SUBJECT: Forwards addl. info re reactivity anomaly that occurred at  
 97.4 effective full power days of operation during Cycle 6,  
 per 801016 ltr. Ref. RO 269/80-23.

Subject: Oconee Nuclear Station  
Docket No. 50-269  
Unit 1 Reactivity Anomaly

Oconee Unit 1 Reactivity Anomaly

Responses to NRC Questions  
of  
October 16, 1980

Figure 1-1

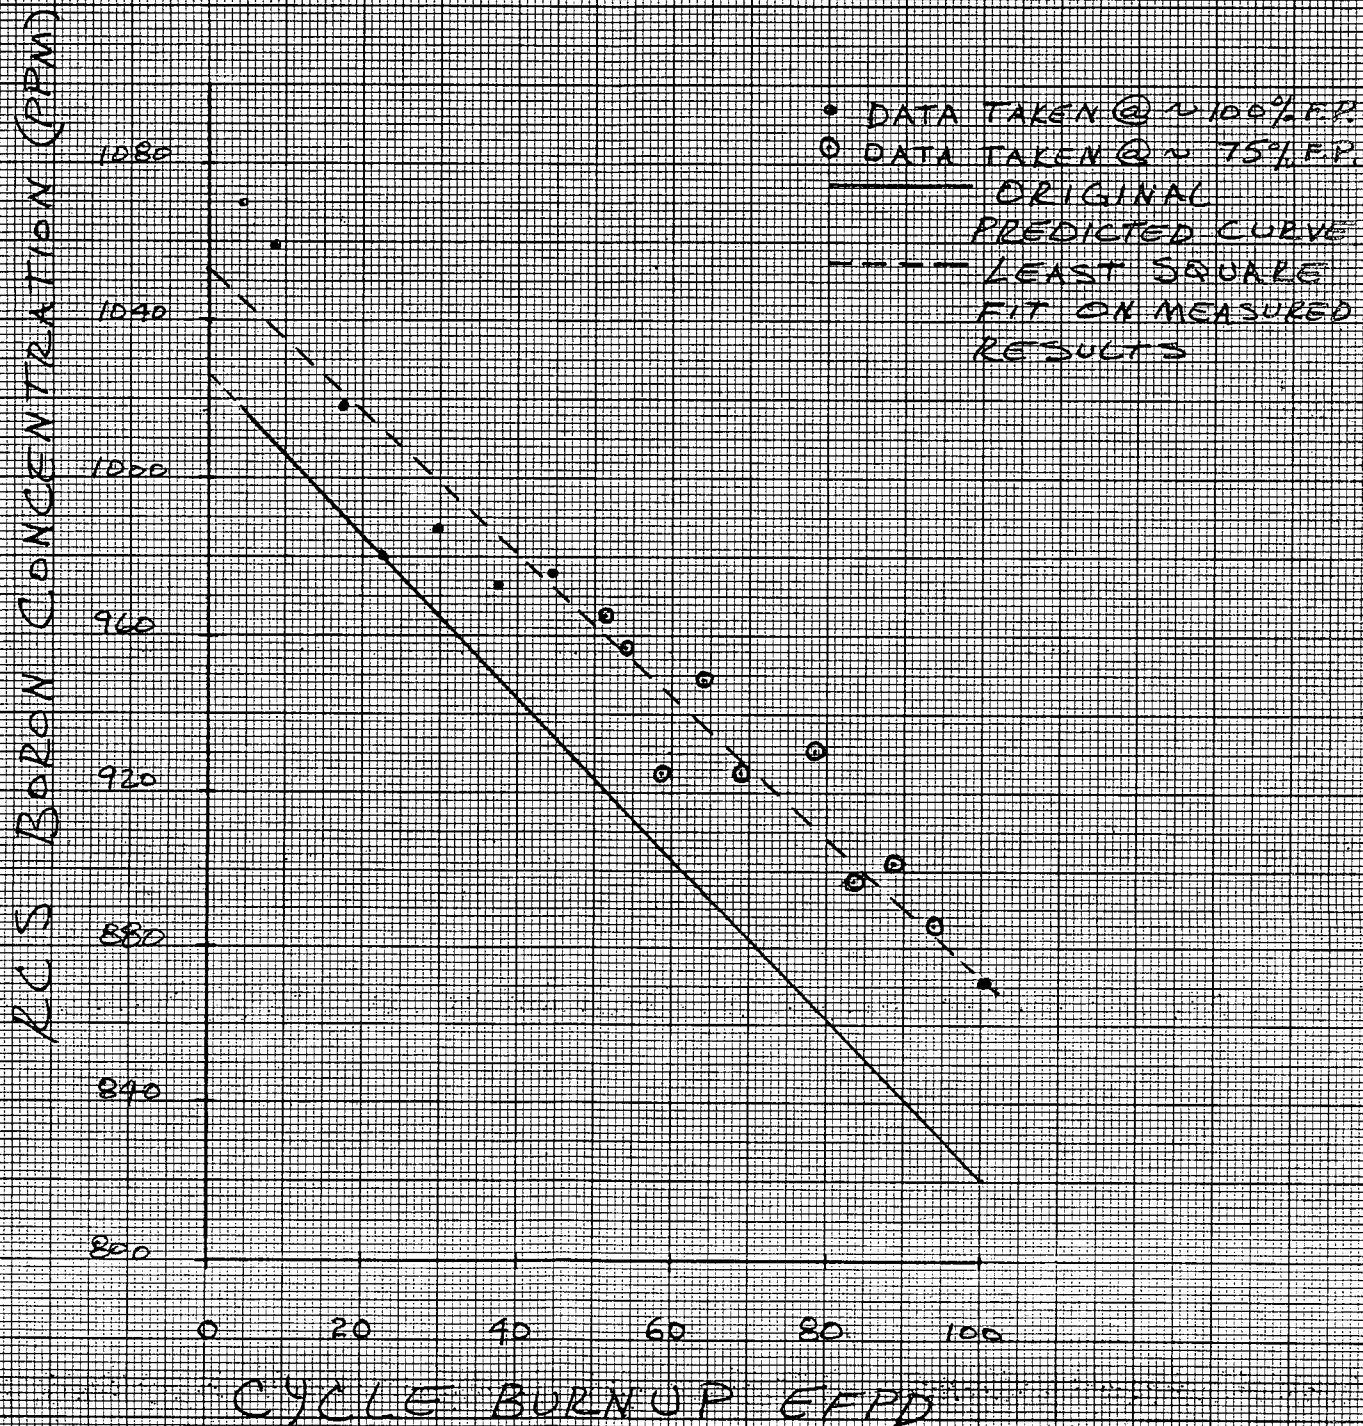
Provide the predicted boron letdown curve and the measurements of critical boron concentration for Cycle 6 for both zero and full power.

The predicted and measured hot full power "All Rods Out" (ARO) boron concentrations through the time of the occurrence are provided in Figure 1-1. The reference conditions for the predicted curve are:

- hot full power
- equilibrium xenon and samarium
- control rod groups 1-8 @ 100% wd
- curve normalized to BOC measured values (i.e., curve is shifted, shape is unchanged)

To confirm that the slope of the original predicted critical boron concentration curve was in error as B&W stated, the results of "all rods out" boron concentration at power measurements were evaluated. As shown on Figure 1-1, a least squares fitted line through the measured data points does have a different slope than was predicted.

Figure 2-1

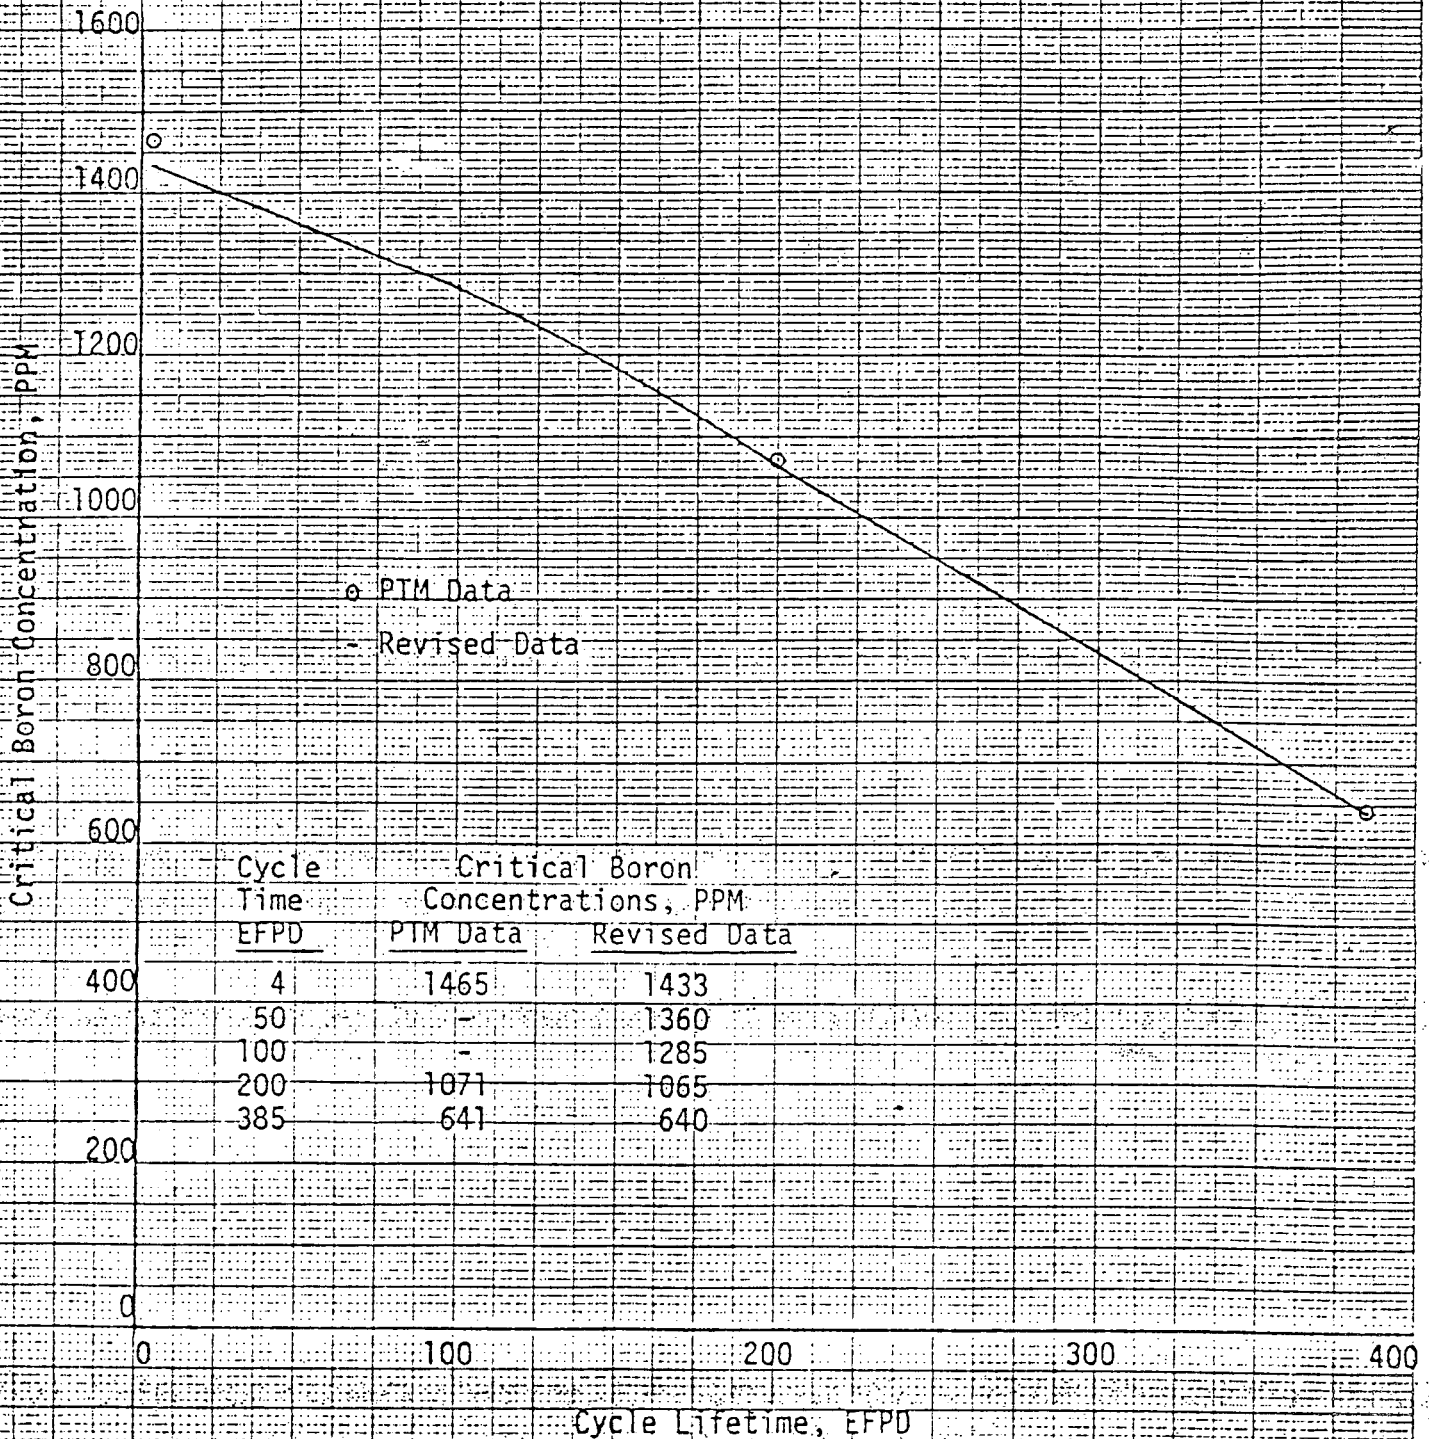
A component of the reactivity anomaly was the underprediction of the core excess reactivity which was based on BOC measurements. Explain why there is a slope change in the excess reactivity curve. Include the originally predicted curve and the revised curve. Why was this not a problem in previous cycles of this or similar reactors?

Oconee 1, Cycle 6 is a lump burnable poison (LBP) cycle. Previous cycles did not contain LBP's. From information gathered from B&W plants having LPB cycles, B&W adjusted the HZP, BOC, AROCBC to account for the differences between the predicted and measured AROCBC. The correction factor is a function of initial LPB loading and decreases with LBP burnup. The correction appears to produce more accurate AROCBC predictions at BOC since B&W plant startups have been within a few ppm of the predicted HZP BOC AROCBC with the correction factor. This LBP correction factor, if applied, would have a decreasing value with burnup becoming essentially zero at approximately 100 EFPD, when the LBP is substantially depleted. Therefore, the burnup dependent LBP correction factor results in a modified slope of the corrected core excess reactivity curve for the 0-100 EFPD portion of the fuel cycle.

However, the functional dependence of the LBP correction on burnup is not fully established. After the Oconee 1 Cycle 6 core physics data was generated, B&W became aware that a correction should be made to the slope of the predicted critical boron concentration (i.e., core excess reactivity) versus burnup curve for the first 100 EFPD of operation. This change was needed because of new information concerning the burnup dependency of the LBP correction factor. This information was not forwarded to Duke; as a result the normalization to beginning of cycle measured data of the core excess reactivity curve in the Reactivity Balance Procedure introduced an error that increased with burnup to a maximum of 0.32%  $\Delta K/K$  at 100 EFPD. The core burnup at the time the reactivity anomaly was observed was 97.4 EFPD--virtually all of the 0.32%  $\Delta K/K$  error was present.

Figure 2-1 is a plot of the original predicted and adjusted (i.e., slope changed) HZP ARO boron curves. These are analagous to the requested core excess reactivity curves.
